PRAIRIE DELL ROAD IMPROVEMENTS – ADDENDUM #1
City of Union, MO
Federal Project STP-6200(607)
December 1, 2014

This addendum is hereby made part of the contract documents of the above referenced project. This addendum supplements and/or amends the originally issued documents and all related addenda.

DATE PREPARED: 12/1/2014
JOB NO.: 1224500
FEDERAL PROJECT NO.: STP-6200(607)
SHEET 8 OF 56

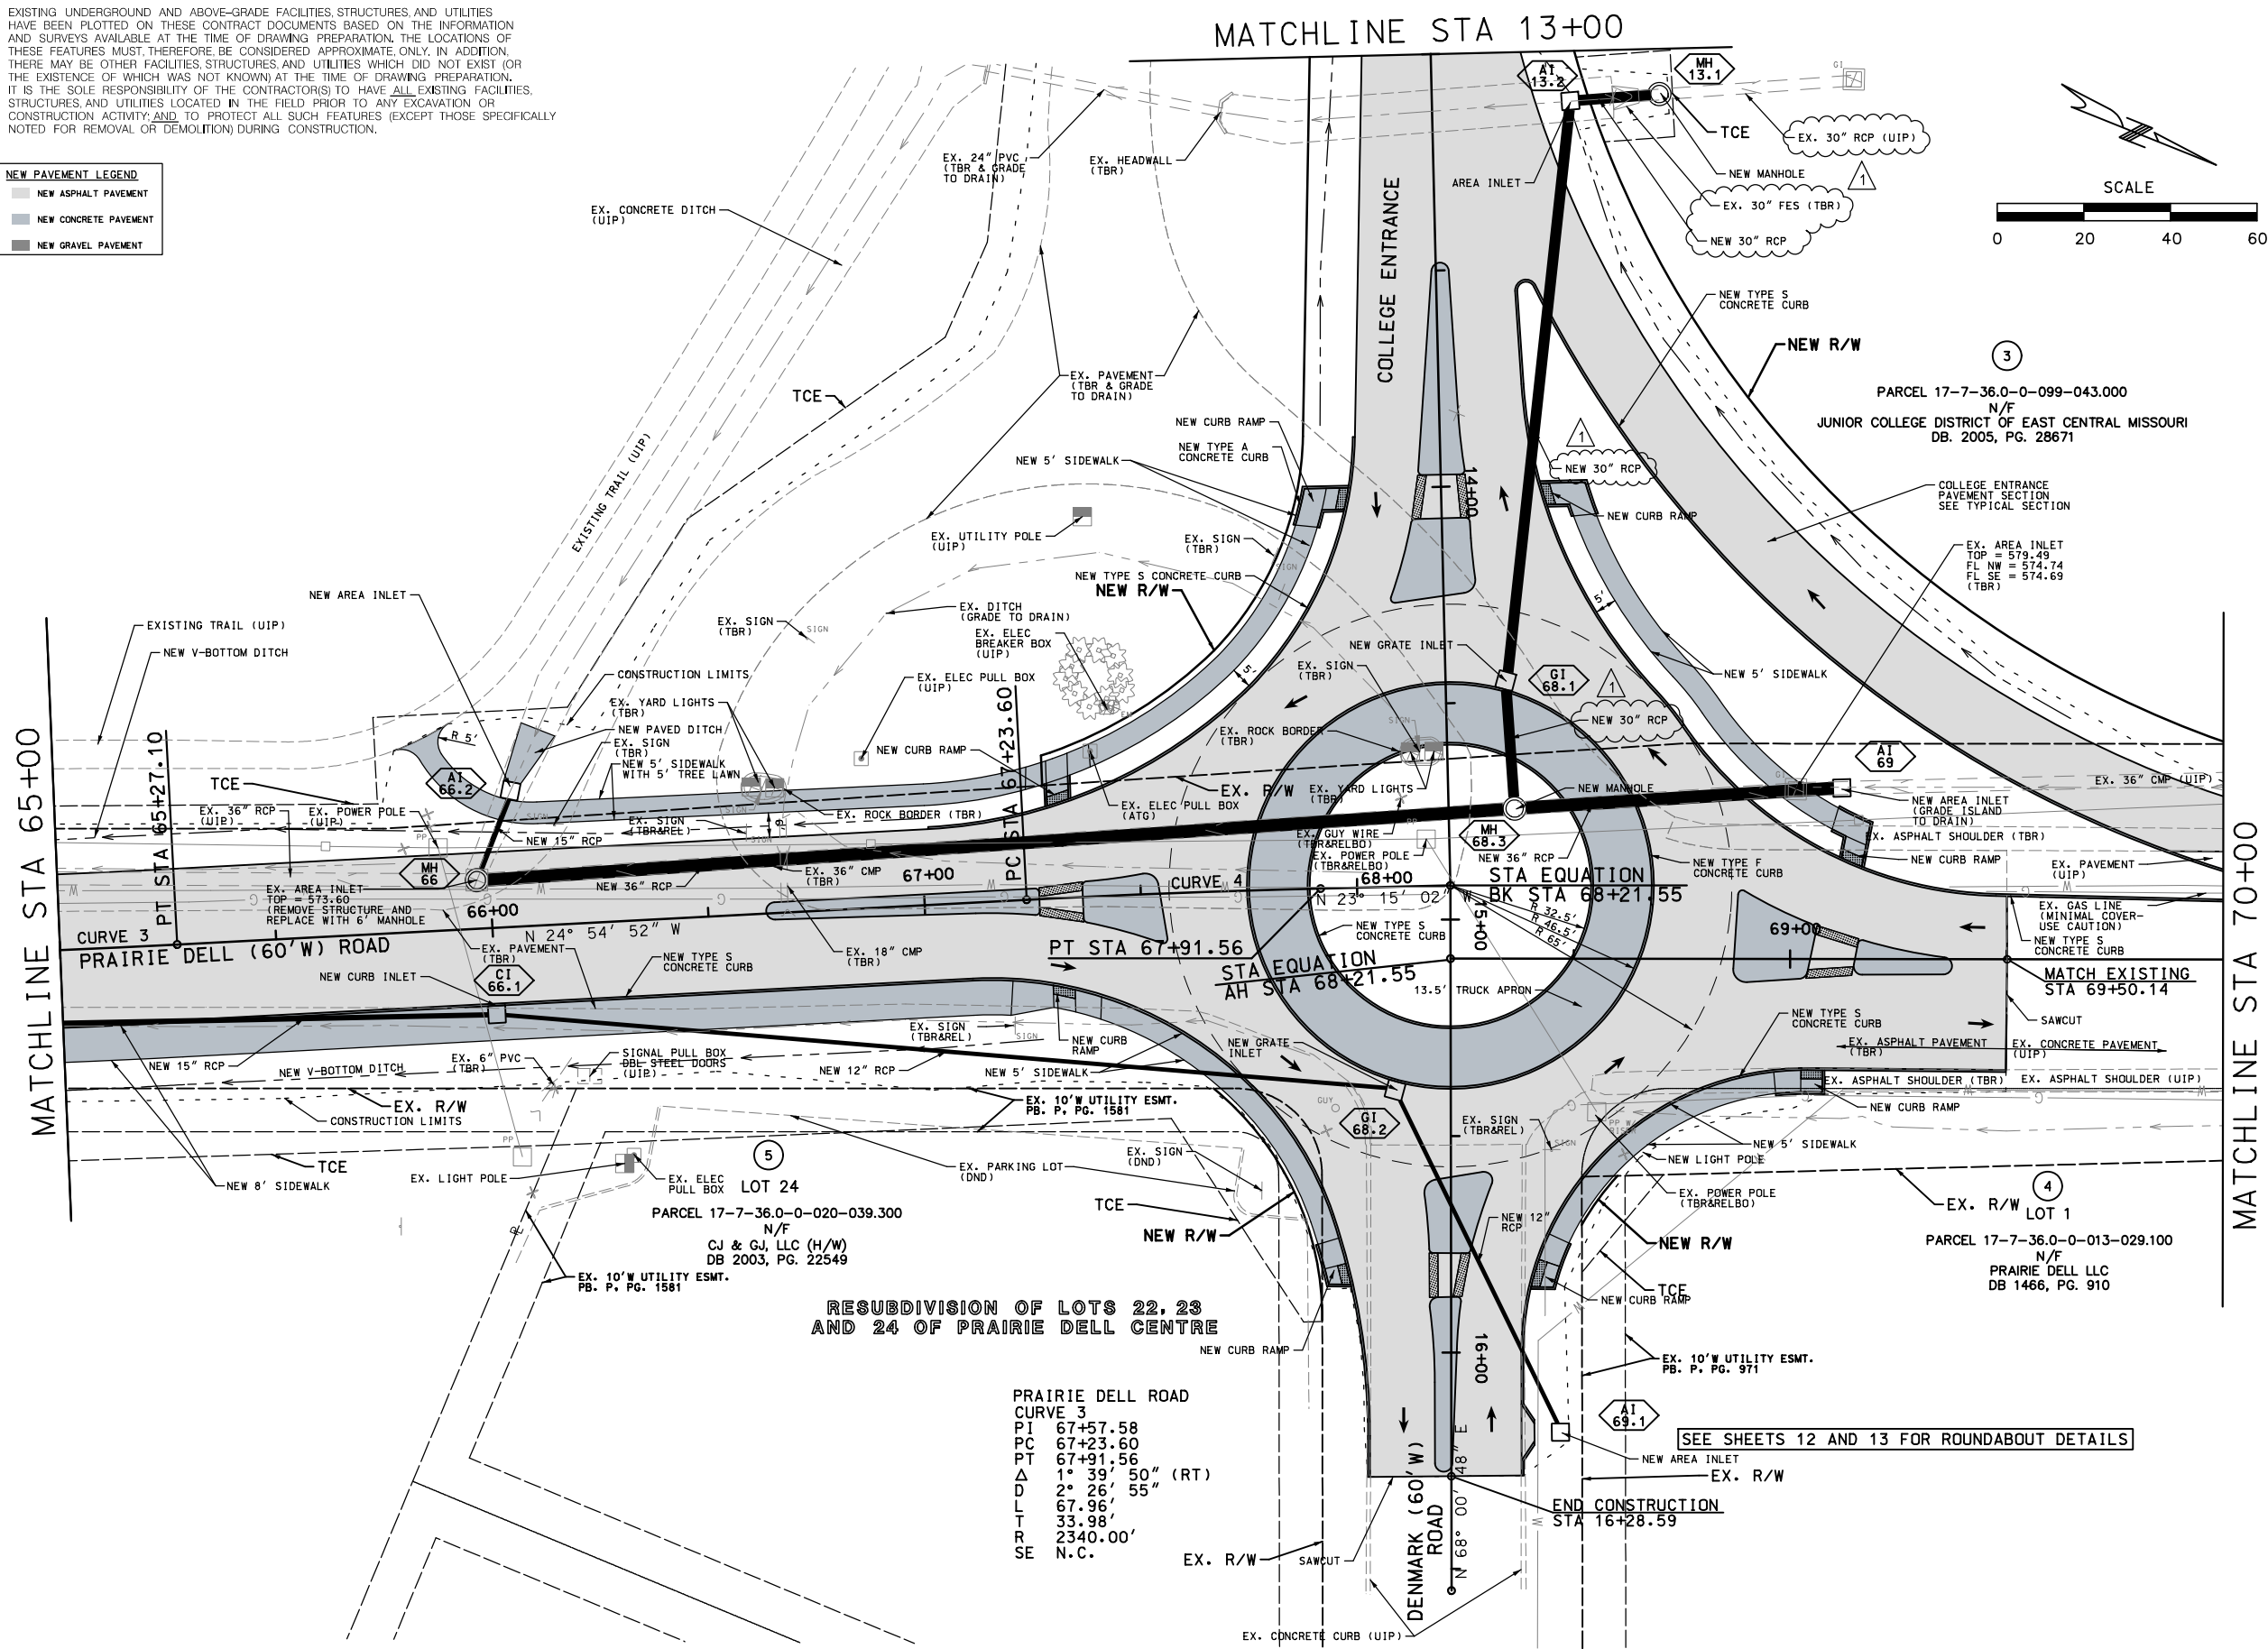
- Sheet 8 revised to correct pipe labels, no change to quantities.
- Sheet 29 revised to reflect direct embedding of light poles.
- Sheet 30 note revised to remove need for ground wire

SHEET 31 OF 56

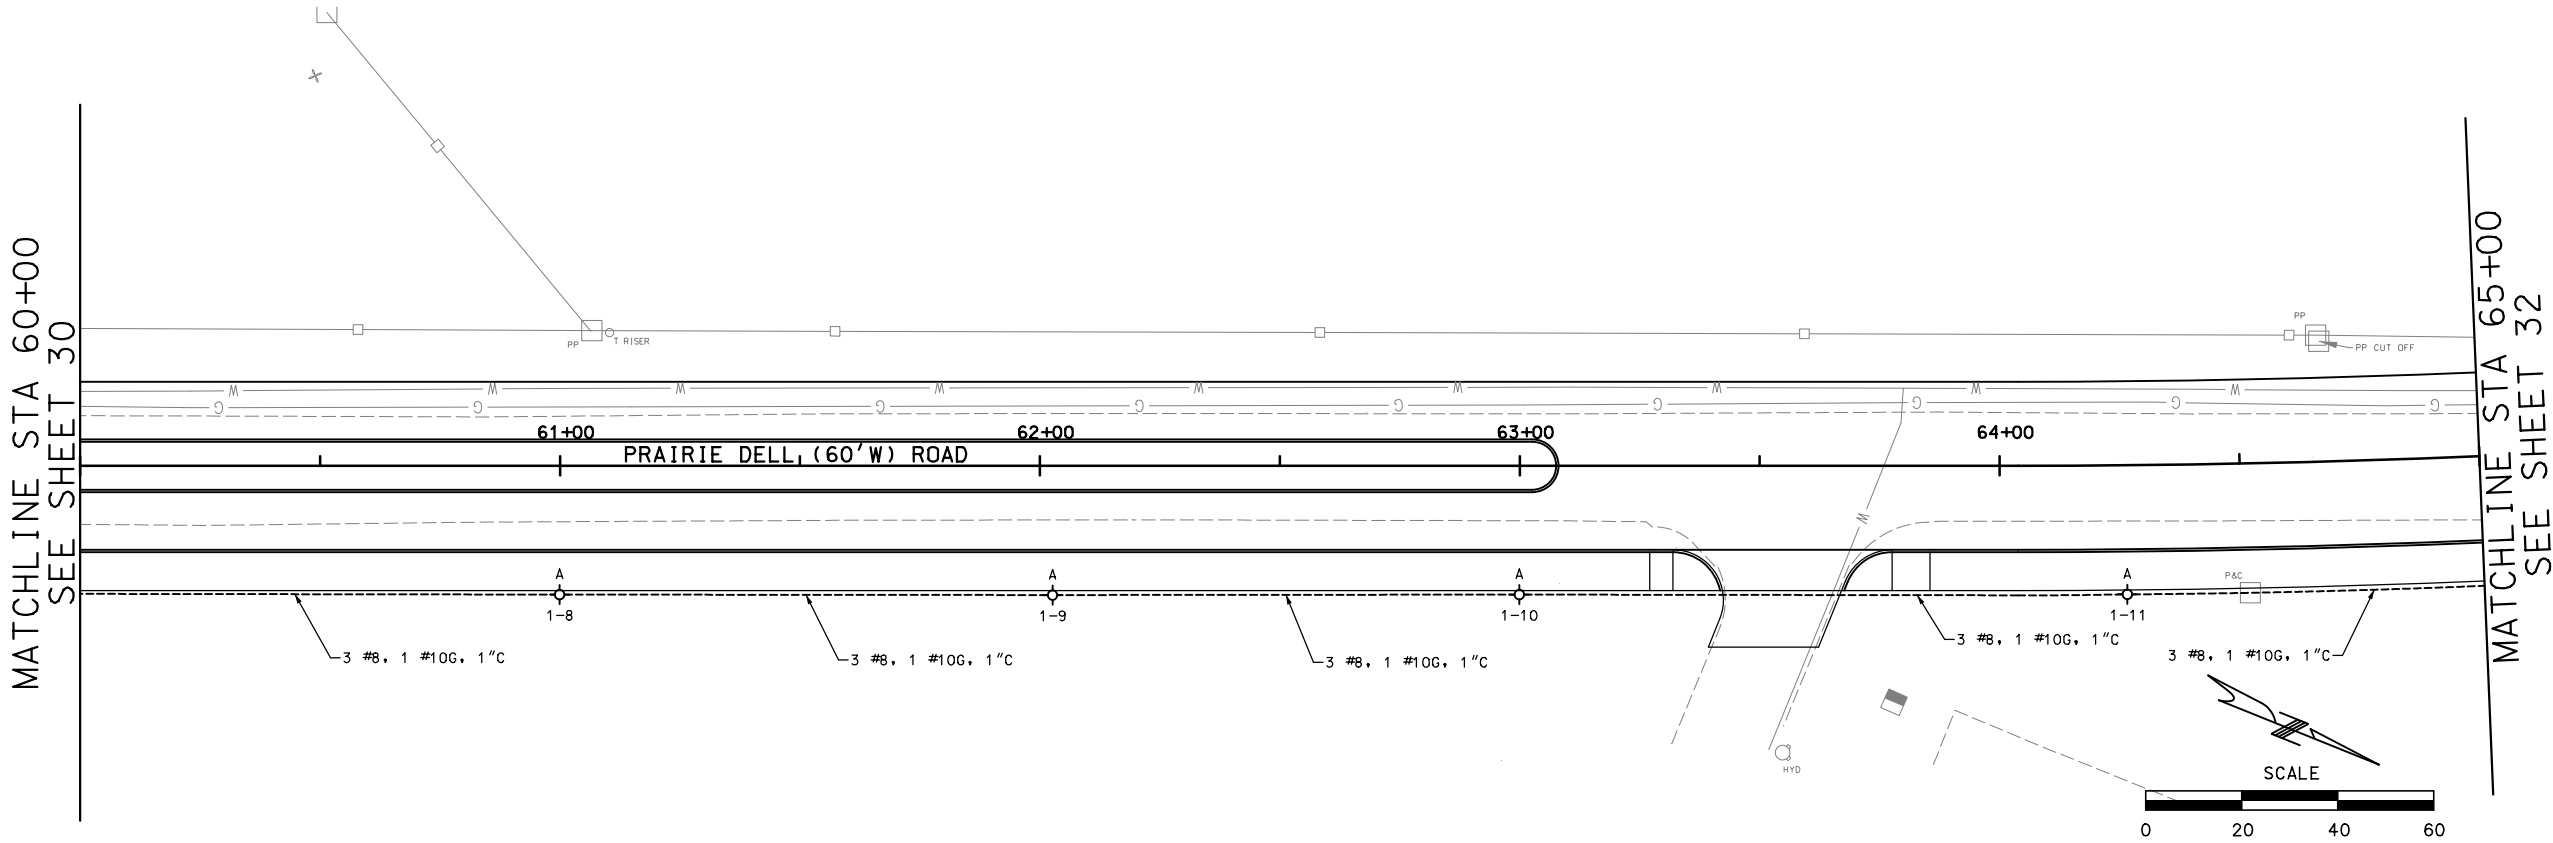
- Sheet 31 revised to reflect the updated quantities.
- Additional Remarks
 - o Polypropylene pipe is allowed as a suitable substitute to reinforced concrete pipes. However, per City of Union ordinances, reinforced concrete pipe shall be required under road pavement.
